Project Name: Madison County Schools - New Tennis Complex

Project Number: 23-034

## ADDENDUM NO. 05

**L1.0**  
LANDSCAPE  
PHASING PLAN

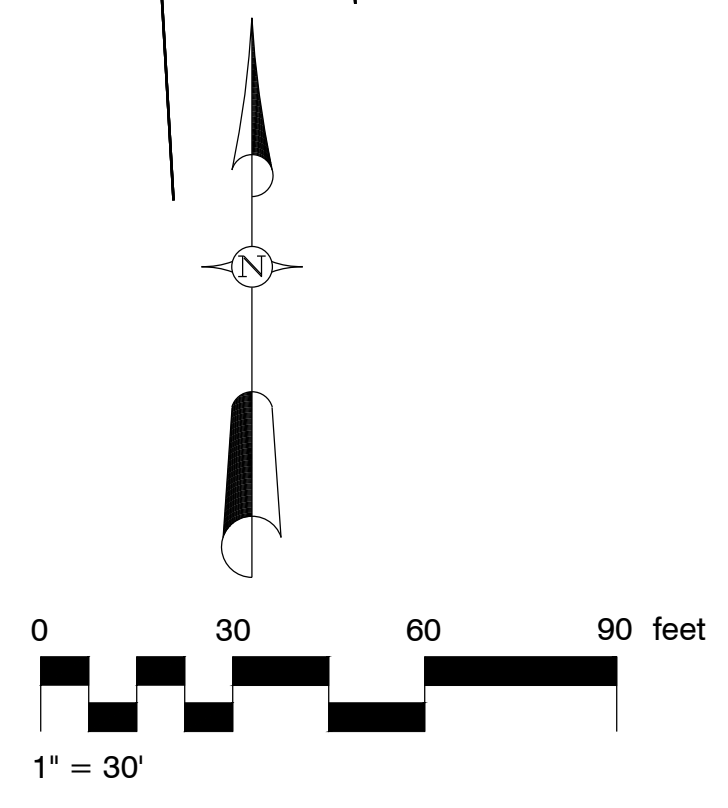
- ITEM NO. 08      **Sheet L1.0 LANDSCAPE PHASING PLAN**  
**ADD** sheet **L1.0**, with the attached **revised L1.0**  
*Clarification:* Sheet **adds** the extents of landscaping to be installed in the base bid and the extents of landscaping to be installed as alternate #5. Sheet also **ADDS** a detail for the maintenance strip perimeter around the complex.
